MANDATORY SERVICE BULLETIN NO. MSB D4-037/2

Modification of engine and power plant installation for better service reliability.

WI-MSB-D4-037

„MODIFICATION OF ENGINE AND POWER PLANT INSTALLATION“

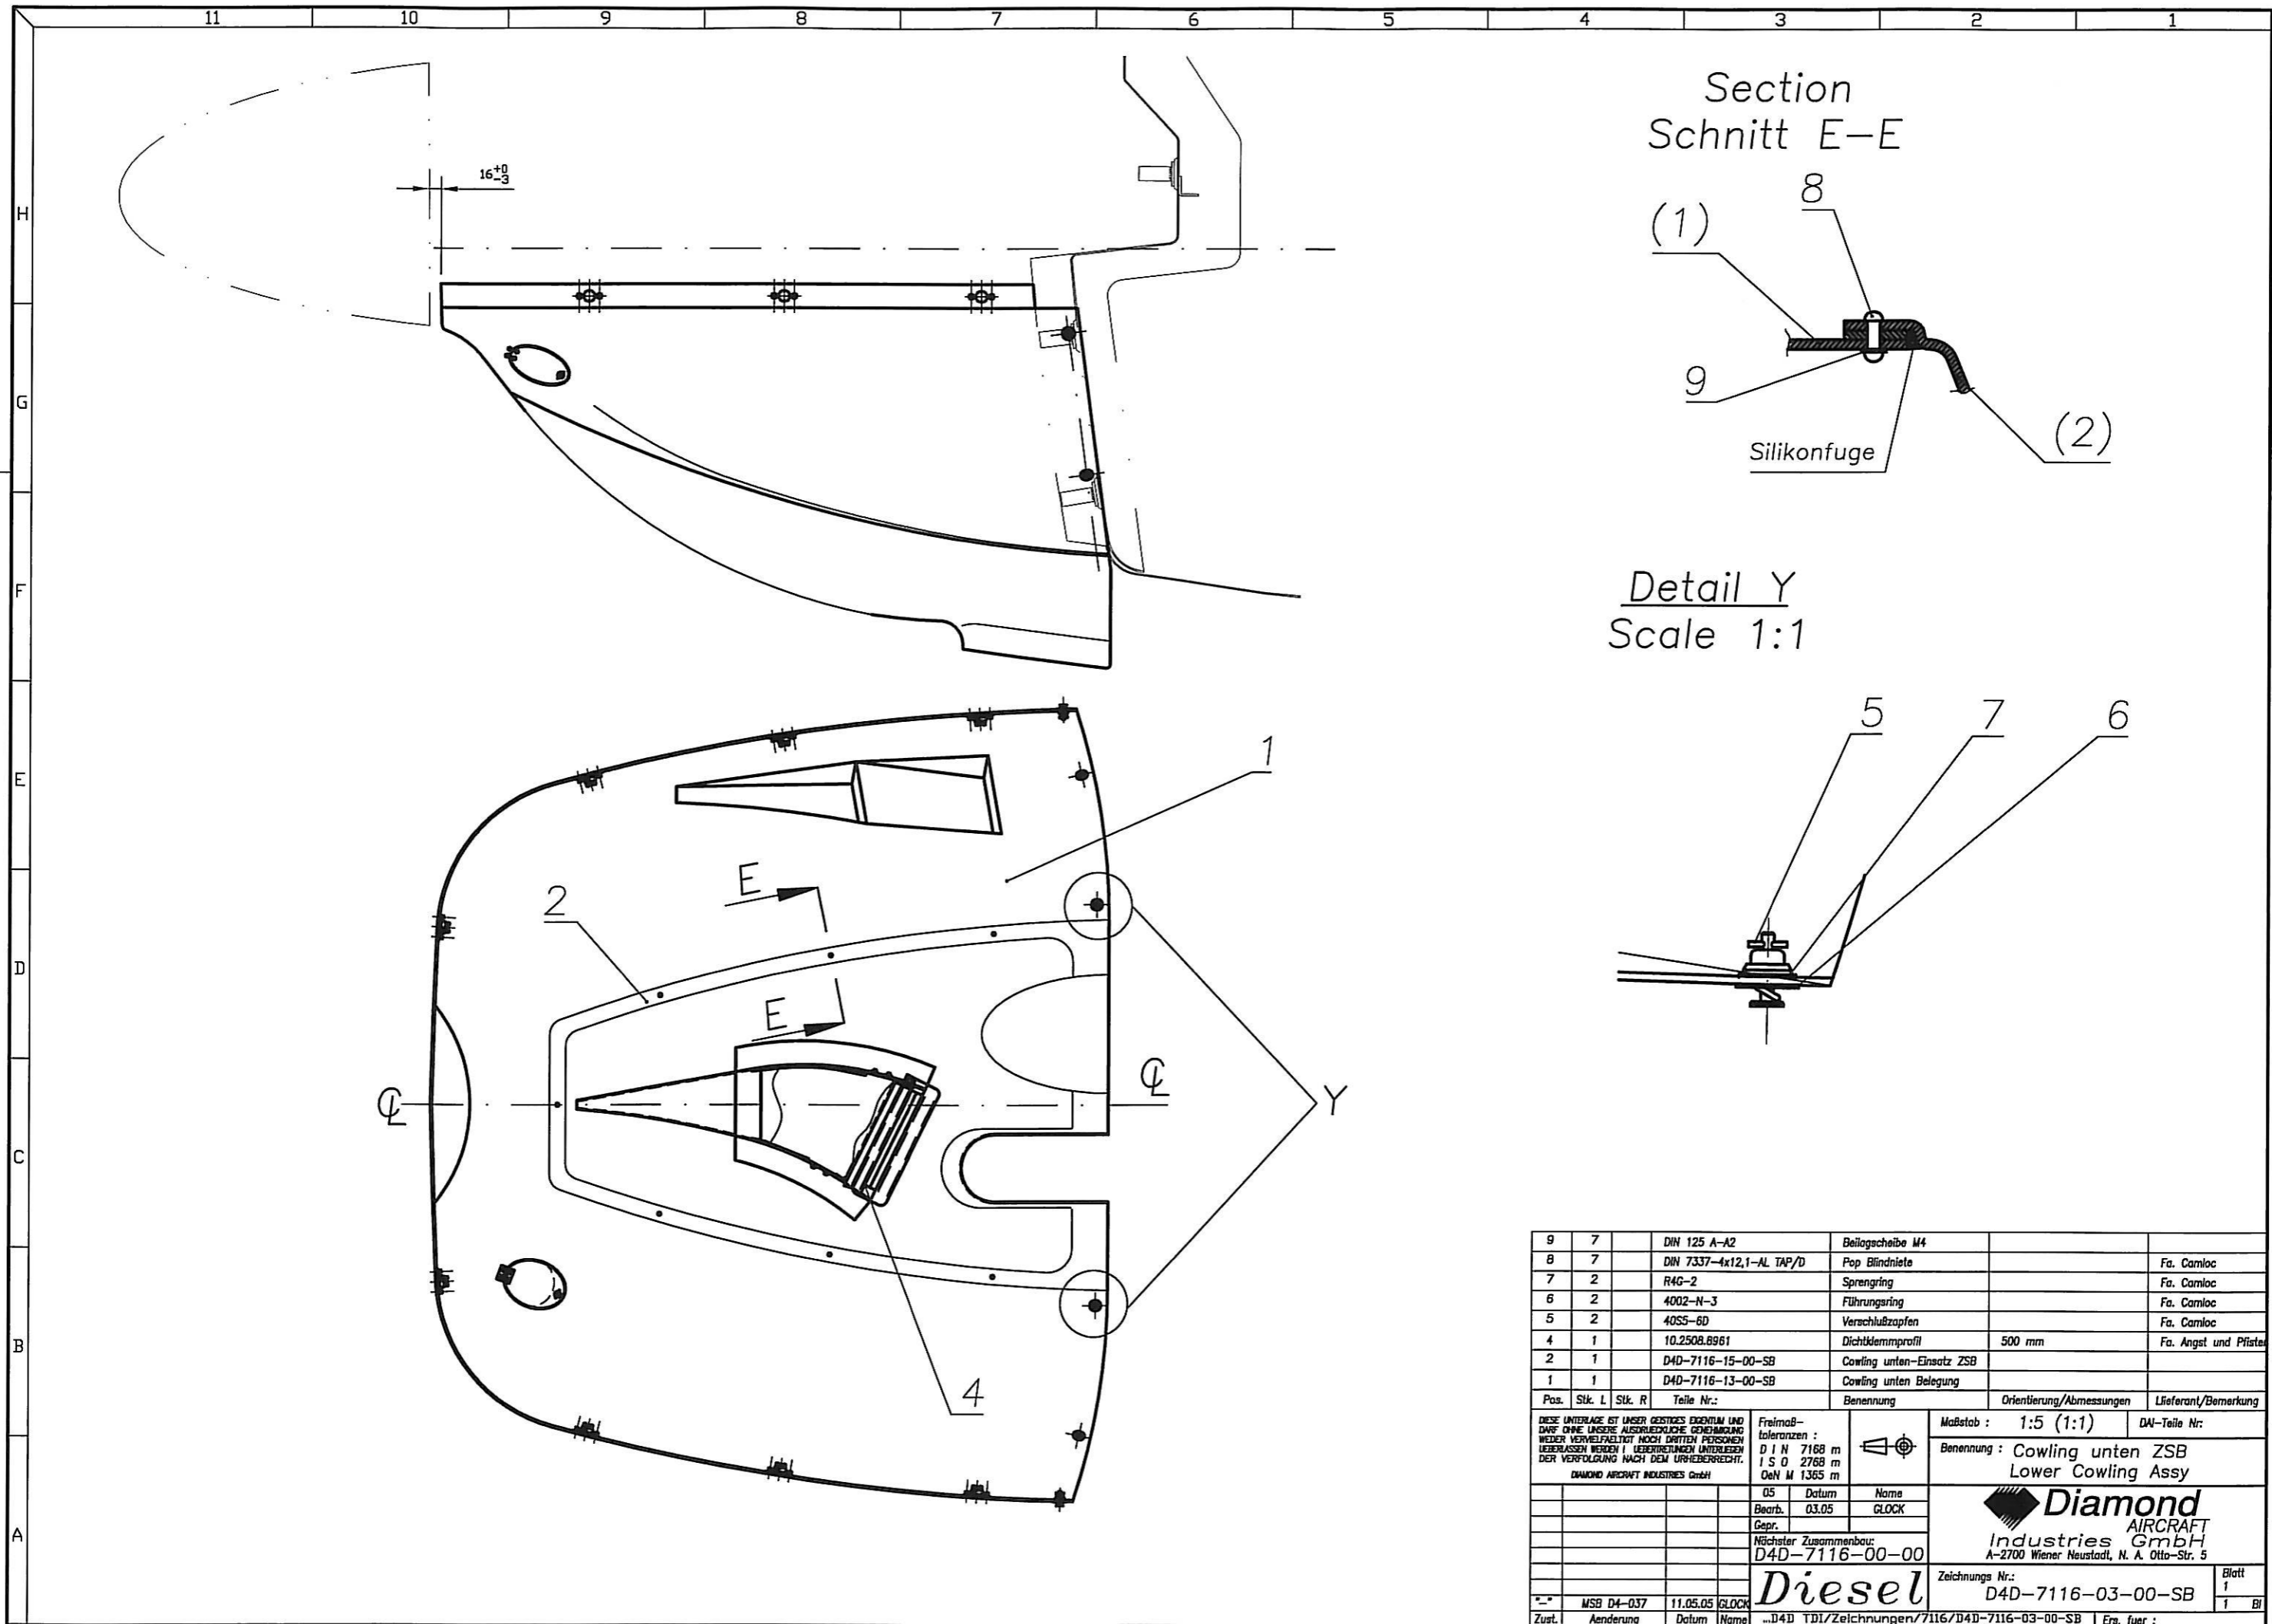
44	Drill holes for positioning from inside of cowling, use holes of cowling insert as template.
45	Remove cowling, tape and cowling insert.
46	Remove peel ply from bonding flange of cowling insert and sand bonding areas carefully on cowling and cowling insert.
47	Use tape to protect the painted areas from resin.
48	Bond in lower cowling insert with thickened resin according to the AMM, Chapter 51. For positioning the new cowling part use 7 rivets TAP/K/BS44, d 4 x 12.1 mm
49	Clean gap in the bonding area from thickened resin.
50	After curing remove tape from painted areas.
51	Post curing in accordance to AMM, Chapter 51.
52	Fill outside gap with white silicone.
53	Apply fire retardant paint on edge of bonding flange of cowling insert (a.r.) (refer to Chapter 51).
54	Drill 2 holes d 12 mm for Camloc studs in cowling insert.
55	Install 2 Camloc studs, part number 40S5-6D, with grommets, part number 4002-N-3, and retaining rings, part number R4G-2, on lower cowling.
